UNITED STATES PATENT AND TRADEMARK OFFICE

APPLICATION NO.	FILING DATE	FIRST NAMED INVENTOR	ATTORNEY DOCKET NO.	CONFIRMATION NO.
10/812,108	03/29/2004	Robert Lee Donovan	BA/Div App	1513
26860	7590	11/30/2005	EXAMINER	
LAW OFFICE OF DUNCAN PALMATIER 530 SOUTH ASBURY SUITE 5 MOSCOW, ID 83843			BURCH, MELODY M	
			ART UNIT	PAPER NUMBER
			3683

Office Action Summary

DETAILED ACTION

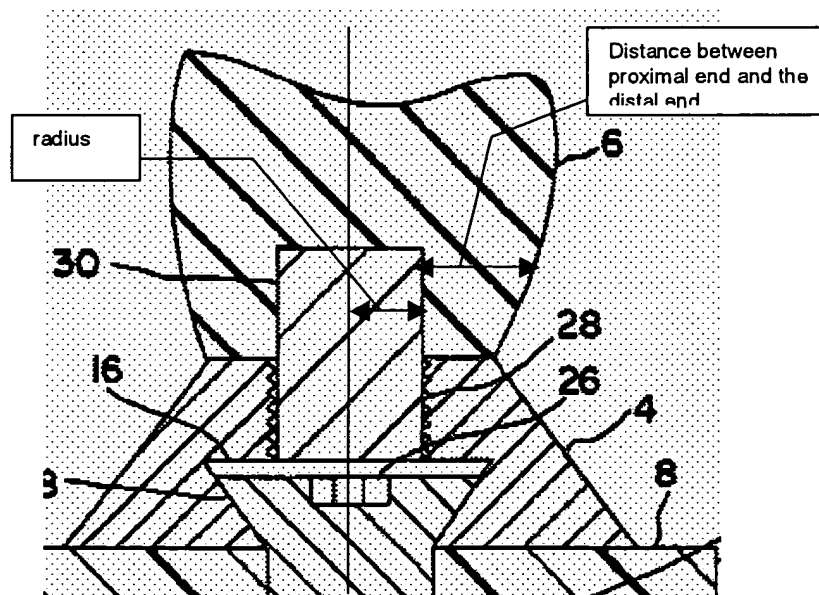
having a cylindrical, ring shaped base with an inner cylindrical ring surface, and an axis along the length of the cylindrical ring shaped base and a radius from the axis to the inner cylindrical ring surface as labeled in the marked up copy of figure 3 on this page, the damper further comprising a plurality of fins shown in the area of the lead line of number 6 shown in figure 2 extending from the ring shaped base in a radial direction from the axis, wherein each of the plurality of radial fins has a fin base at a proximal end of the fin at the ring base and a fin tip at a distal end of the fin, and wherein the radial fins are not constrained and are free to vibrate and wherein the distance between the proximal end and the distal end of the fins is at least as great as the radius as shown in the marked-up copy of figure 3 below, and wherein the inner cylindrical ring surface fits over the cylindrical projection or portion 30 of the cylindrical projection of the archery bow.

Re: claim 19. Leven shows wherein the cylindrical projection of the archery bow is a mounting cup 26 sized to be disposed within the inner ring surface of the vibration damper.
